TAMPA ELECTRIC

December 21, 2007

Re: Tampa Electric Company - Big Bend Station
Big Bend Unit 3 and Unit 4
Modifications to Selective Catalytic Reduction System Permits
DEP File 0570039-030 AC
DEP File 0570039-031 AC
Duct Work Separation for Scrubber Tower

FIGURE 1 - DUCT SPLIT DIAGRAM

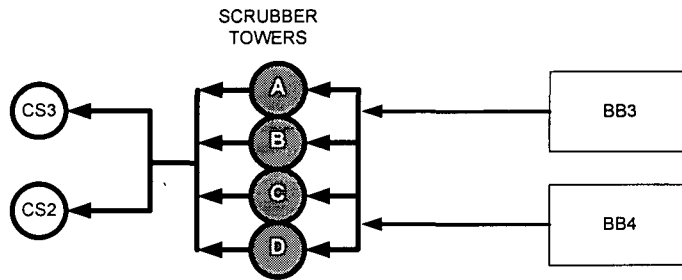
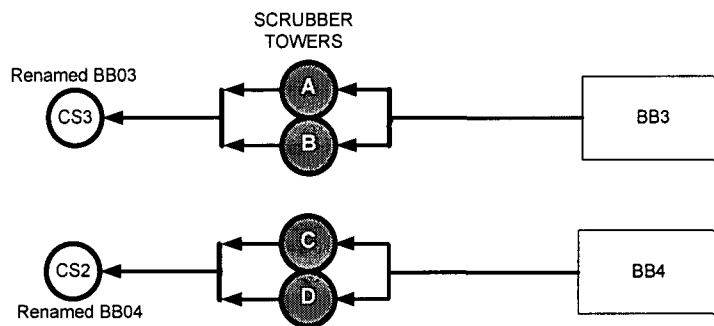
- In Section 9.0, FDEP describes the basis for claiming this project triggers permitting requirements. TEC disputes the claim that “normal operations have not yet commenced under the split mode with actual separation of the modules compared with the original configuration of Unit 4.” Unit 4 has operated in the two-module configuration that is proposed after the duct split and this mode of operation comports with current permit requirements. Likewise, Unit 3 has also operated in this mode. During 2007 alone, Unit 4 operated in the two-module mode for 29 days and Unit 3 operated in this mode for 62 days. The fluid dynamics of the system have always had a tower bias where the flue gas would naturally travel the path of least resistance. Therefore, normal operations have commenced as each unit alone can run with any number of towers, however load may be adjusted to ensure removal efficiency requirements are met. As a result, the future potential test is not applicable. As depicted in Figure 1 below, the duct split project is simply a new plumbing arrangement designed to preclude the loss of two boilers due to a scrubber outage after 2009, when the ability to operate unscrubbed expires. Ductwork itself has no impact on emissions and we are proposing no changes to the scrubber, therefore this duct split project cannot cause an increase in actual or potential emissions by any interpretation of the definition. Furthermore, any potential emissions increase due to increased unit availability is offset by reductions realized by operating Unit 3 scrubbed 100% of the time after 2009. Regardless, it should be noted that this project is designed to preserve unit availability at current levels while reducing overall emissions.
